Aeronautical Study No.
2007-AWP-7320-OE
Prior Study No.
2007-AWP-6408-OE

**** DETERMINATION OF NO HAZARD TO AIR NAVIGATION ****

From: John Kessler
To: Docket Optical System; Jim Adams
CC: Eric Knight
Date: 1/28/2008 8:59 AM
Subject: Fwd: VV2 FAA Update
Attachments: re-filed FAA 7460-1.doc; Victorville 2 - FAA Determ of No Hazard to Air Navig - Cooling Tower (1-10-08).pdf; Victorville 2 - FAA Determ of No Hazard to Air Navig - Solar Field (1-10-08).pdf

Please docket this email and the attached files to Victorville 2 (07-AFC-1). I have downloaded the two Determination of No Hazard files from FAA's website as applicable for the cooling tower and solar field.

Verified Map for ASN 2007-AWP-7320-OE

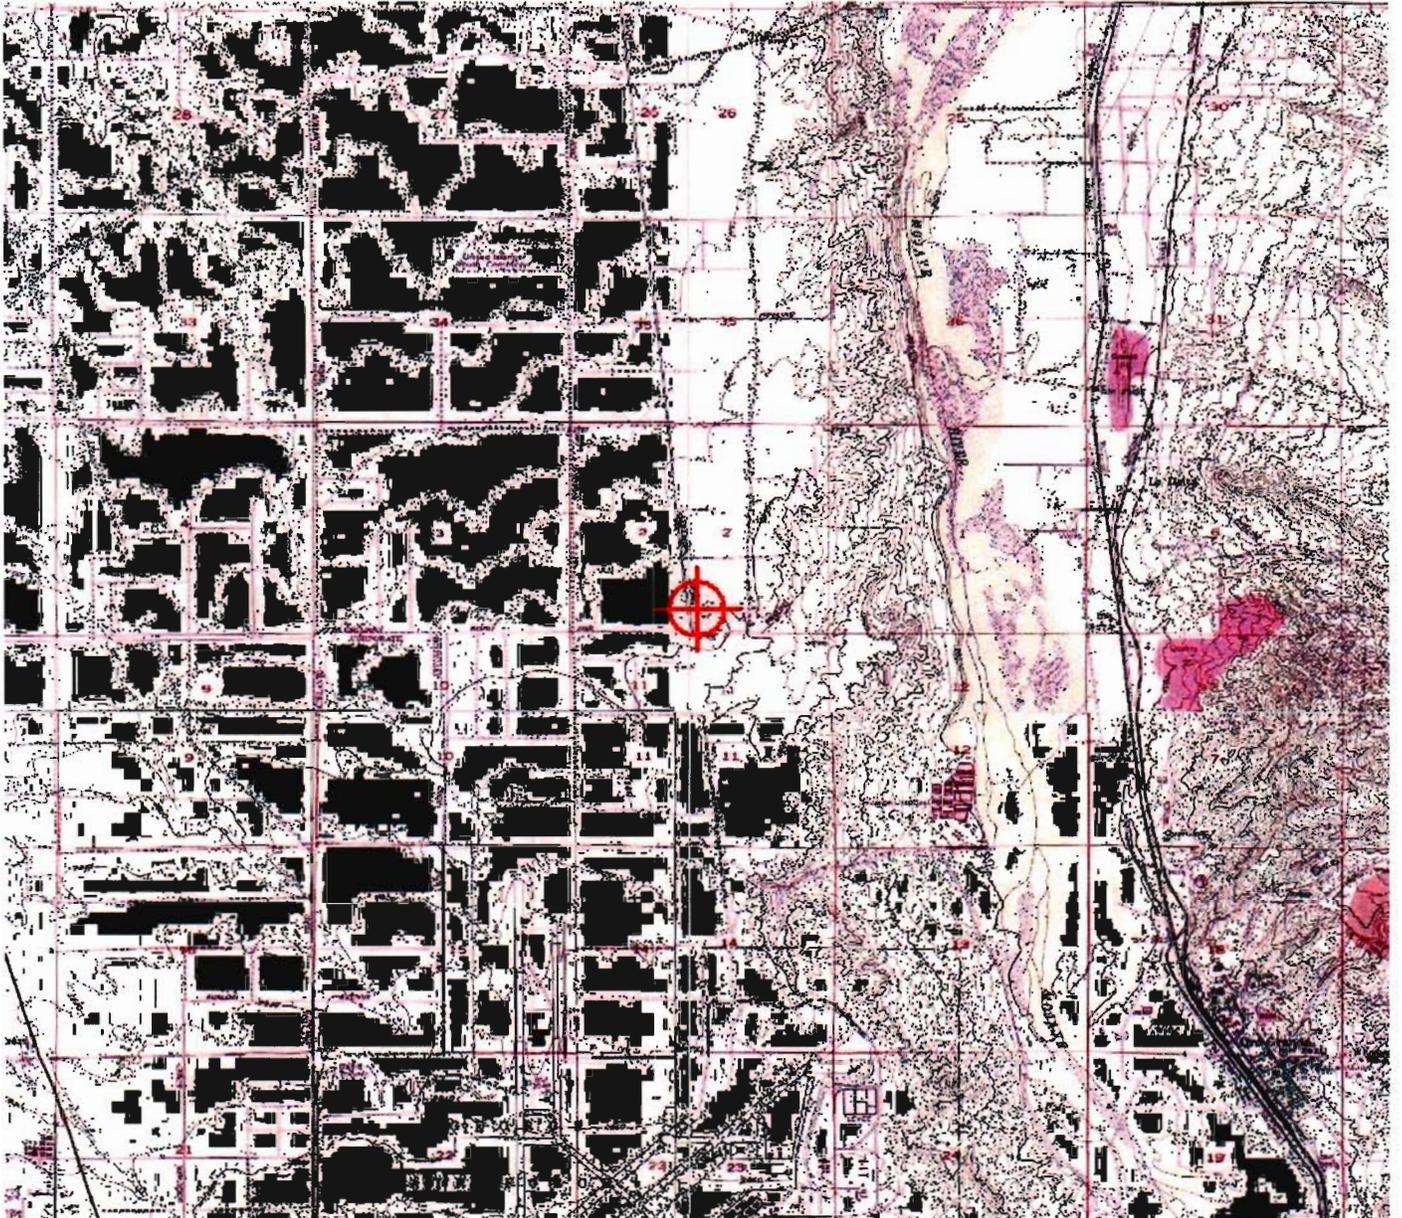
Structure: 250 Acre Solar Mirror Array
Location: Victorville, CA
Latitude: 34-37-55.67N NAD 83
Longitude: 117-22-27.54W
Heights: 20 feet above ground level (AGL)
2820 feet above mean sea level (AMSL)

This aeronautical study revealed that the structure does not exceed obstruction standards and would not be a hazard to air navigation provided the following condition(s), if any, is(are) met:

Based on this evaluation, marking and lighting are not necessary for aviation safety. However, if marking and/or lighting are accomplished on a voluntary basis, we recommend it be installed and maintained in accordance with FAA Advisory circular 70/7460-1 K Change 2.

Verified Map for ASN 2007-AWP-7318-OE

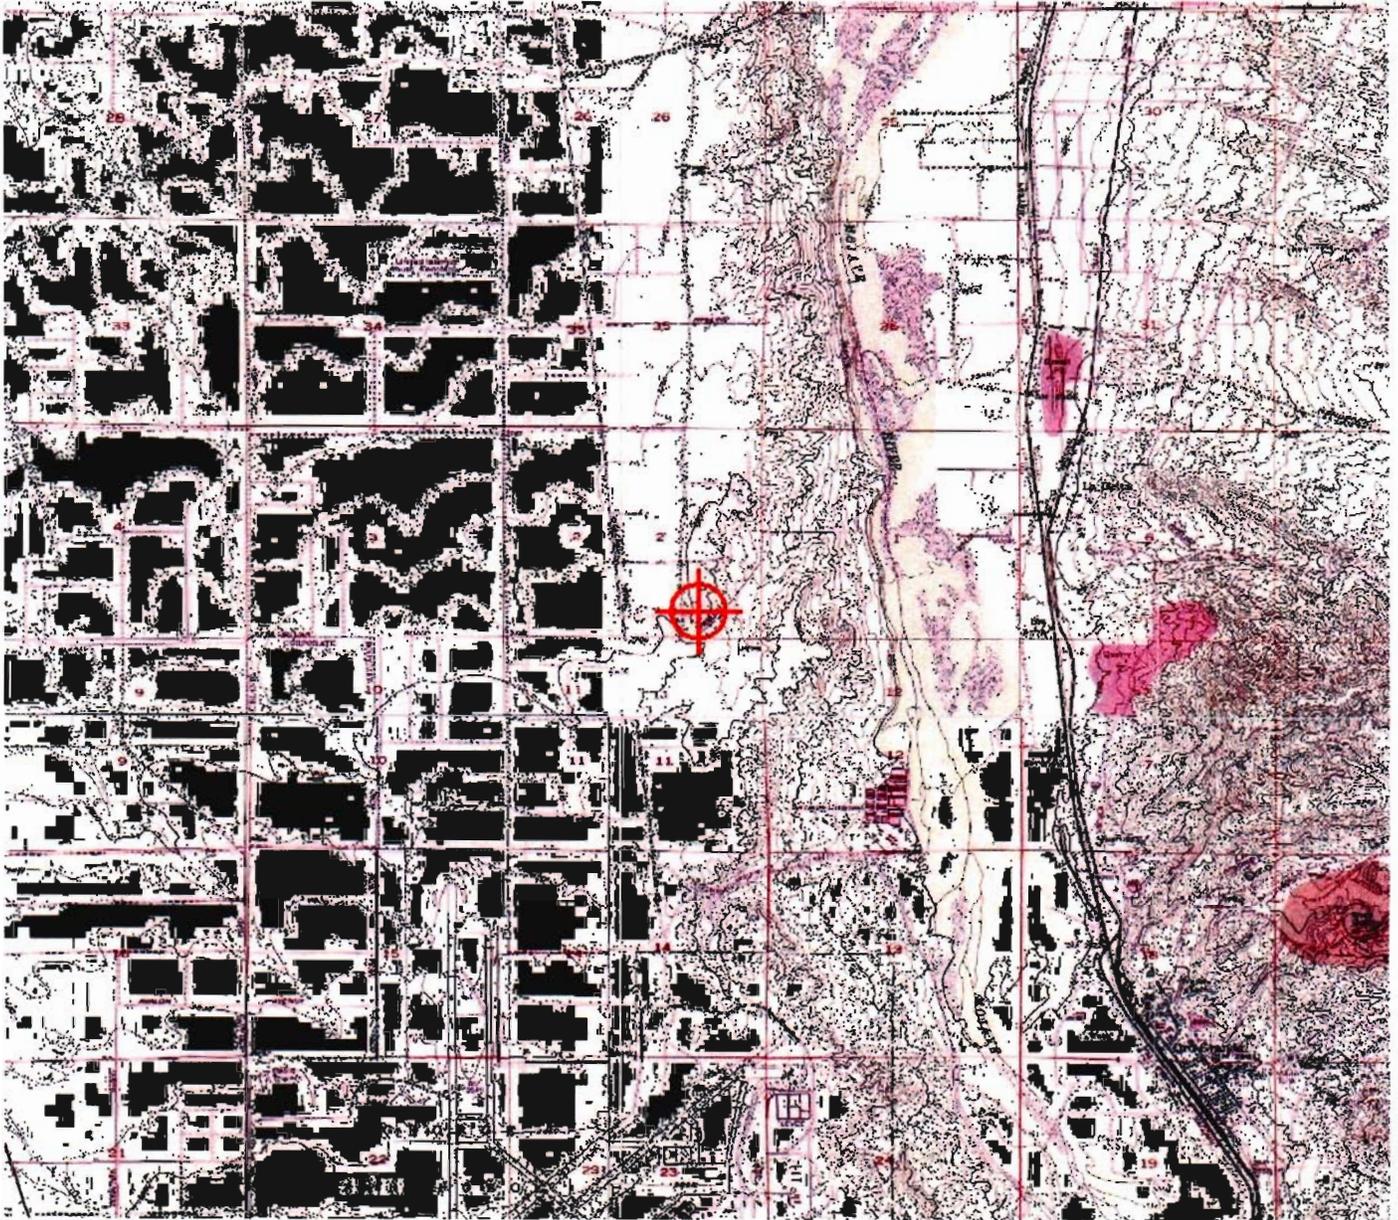
Structure:	Tower Cooling Tower
Location:	Victorville, CA
Latitude:	34-37-56.68N NAD 83
Longitude:	117-22-10.91W
Heights:	60 feet above ground level (AGL) 2860 feet above mean sea level (AMSL)

This aeronautical study revealed that the structure does not exceed obstruction standards and would not be a hazard to air navigation provided the following condition(s), if any, is(are) met:

Based on this evaluation, marking and lighting are not necessary for aviation safety. However, if marking and/or lighting are accomplished on a voluntary basis, we recommend it be installed and maintained in accordance with FAA Advisory circular 70/7460-1 K Change 2.

The structure considered under this study lies in proximity to an airport and occupants may be subjected to noise from aircraft operating to and from the airport.
